- B. VARIANCE REQUEST, WALSH COLLEGE c/o VALERIO DEWALT TRAIN ASSOCIATES, 3838 LIVERNOIS – In order to construct modifications to the existing building: 1) a 10 foot variance to the 25 foot maximum allowed building height; 2) a 5.15 foot variance to the required 80 foot setback from adjacent residential property; and 3) a 4 foot variance to the maximum permitted 35 foot height limit for proposed rooftop mechanical equipment screening structures.

WALSH COLLEGE LIVERNOIS ROAD AND INTERIORS 3838 LIVERNOIS RD. TROY, MI 48083

Preliminary Site Plan Review For City of Troy, Michigan

SHEET NUMBER
A0-01

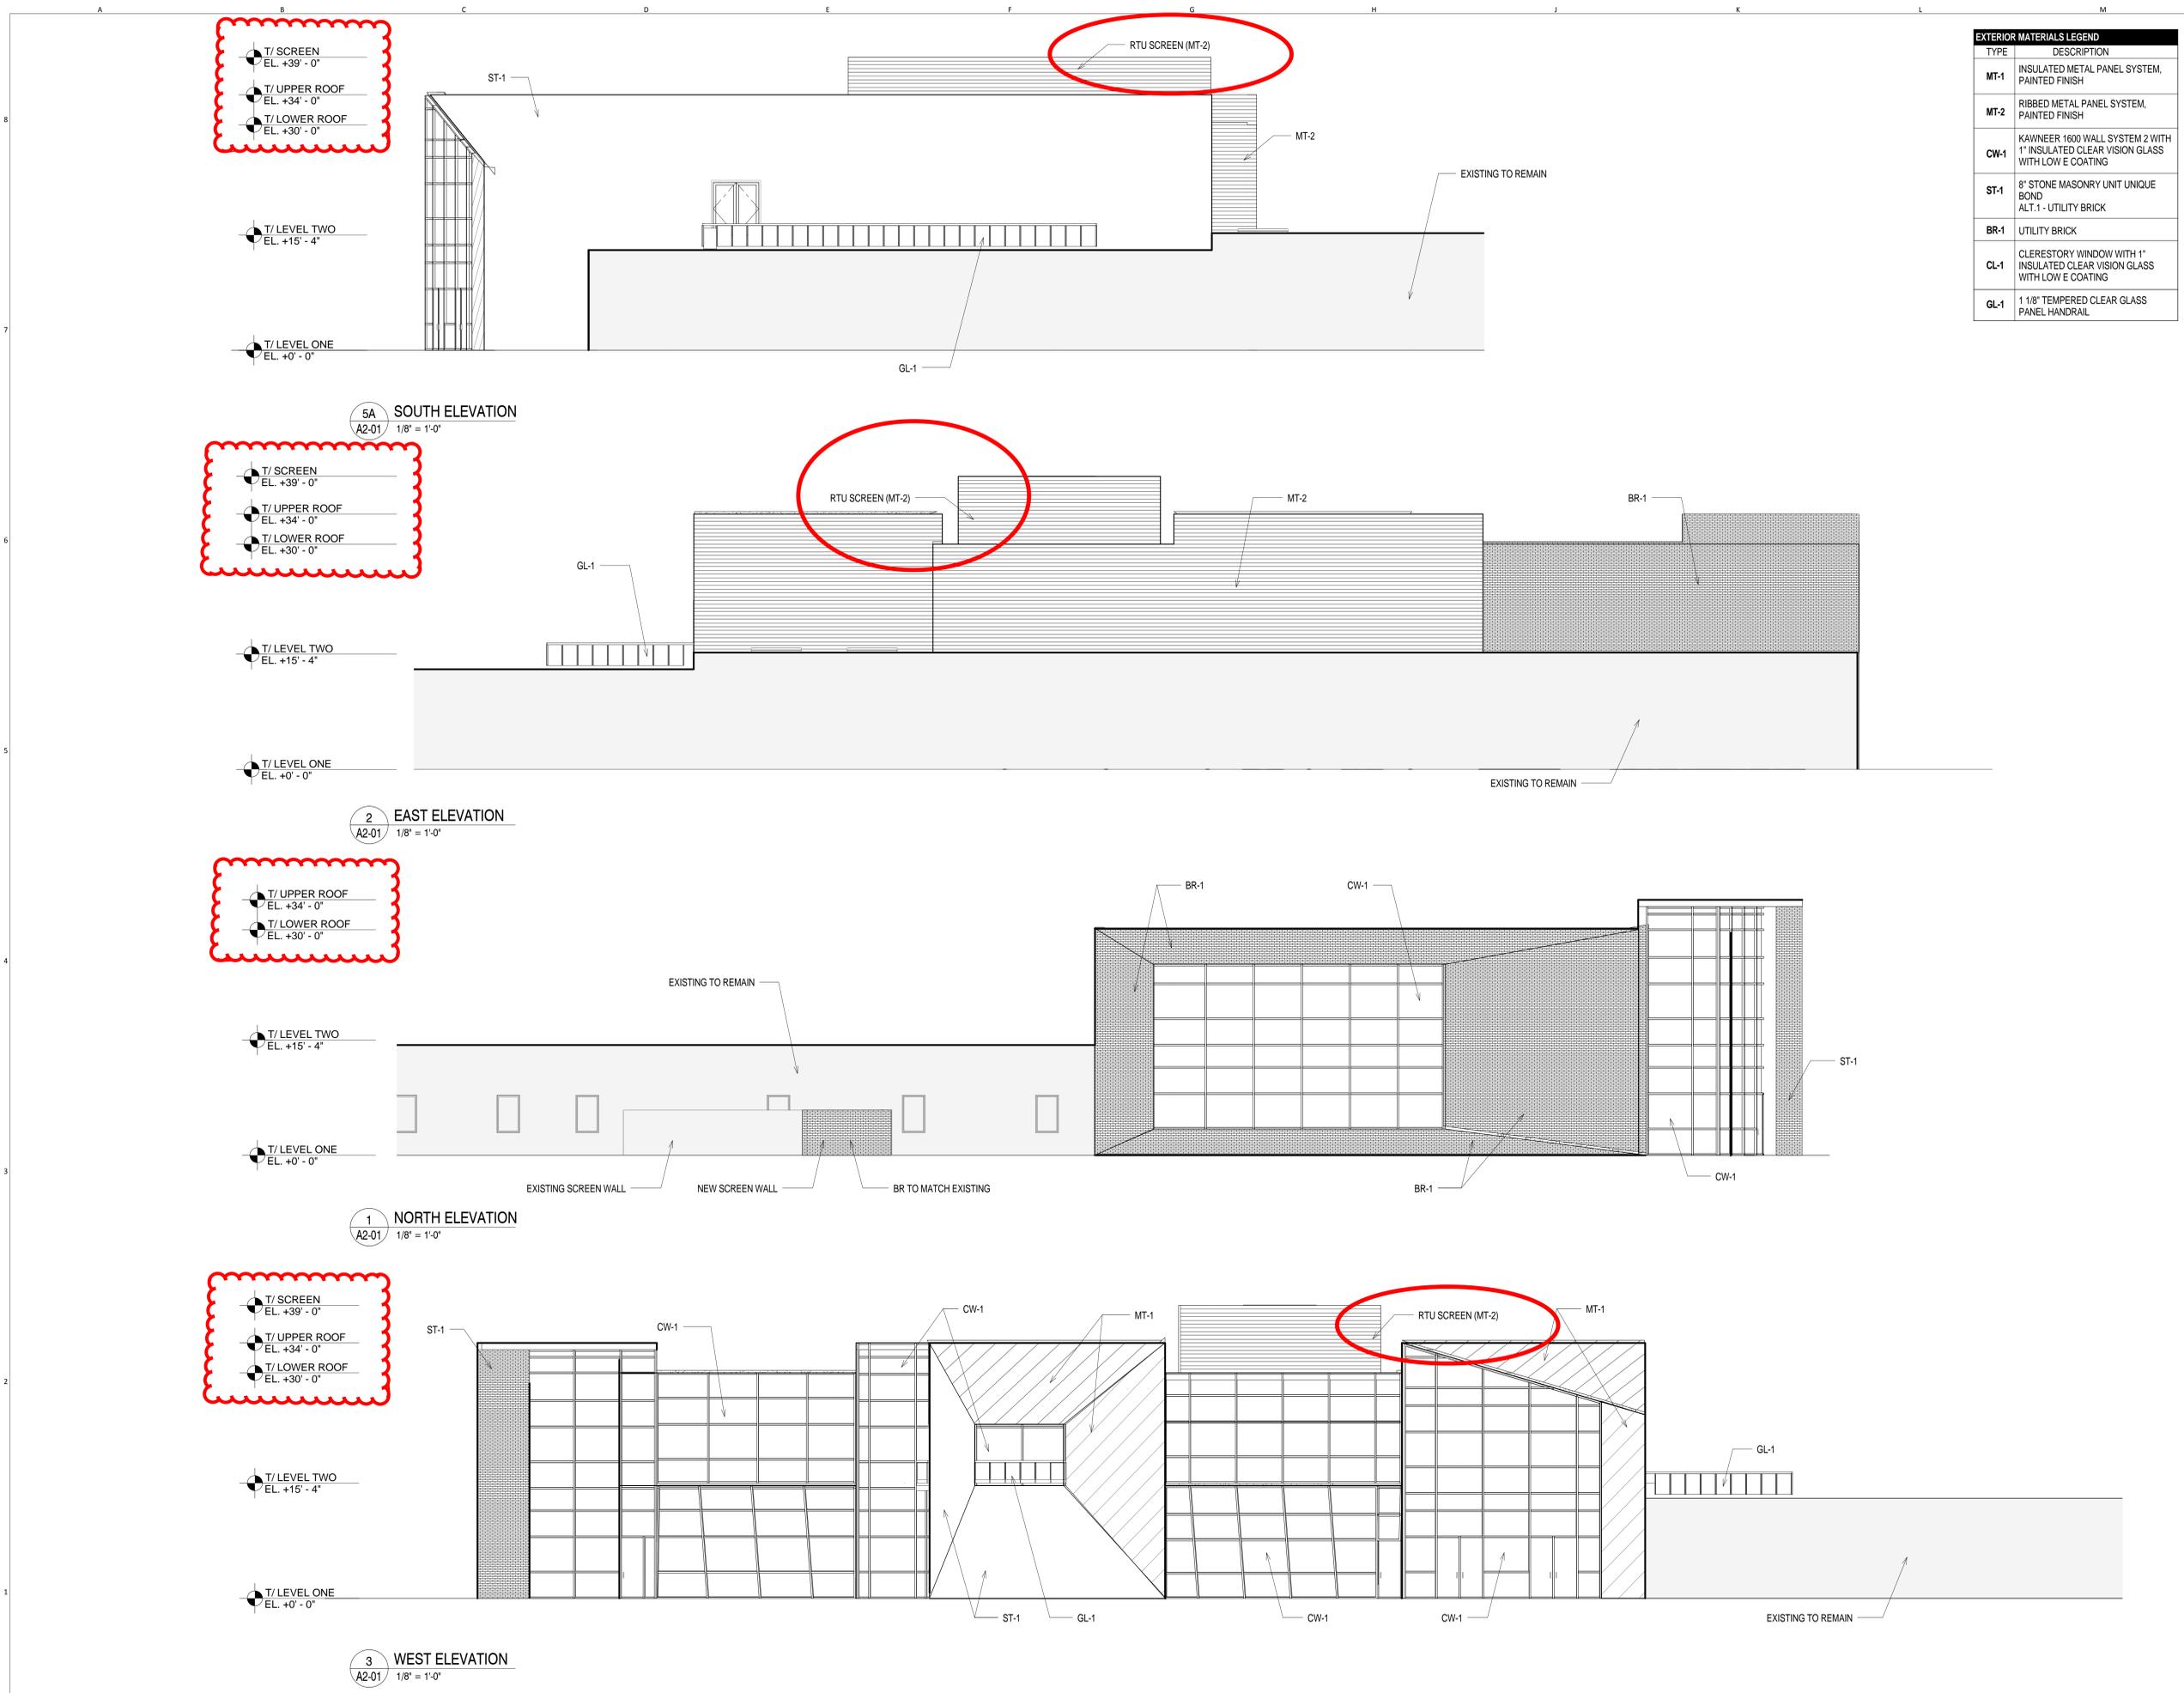
The site plan proposes the addition of a new generator to the existing generator location along the northern elevation of the building, for a total of two (2) generators servicing the site. Changes to equipment screening are subject to the requirements of Section 13.04, Equipment Screening, in the Zoning Ordinance. Per the site plan, the existing screening wall for the generator location will be extended westward and the existing gate relocated to accommodate the additional generator. The extension of the screening wall will be at least as high as the equipment being screened and composed of the same type of brick to match existing construction materials. The applicant will need to supply an elevation of the screen wall on their plans. Rooftop screening is proposed for roof-mounted equipment. The screening consists of a ribbed metal panel system with a painted finish and shall be as tall as, or taller than, the equipment that is being screened.

Items to be addressed: Provide an elevation of the screen wall on the plans.

1. *Provide an elevation of the screen wall on the plans;*
2. *Reduce the lighting levels to no more than 20 footcandles; and*
3. *Address potential glare from interior lights to the adjacent residential property to the north.*
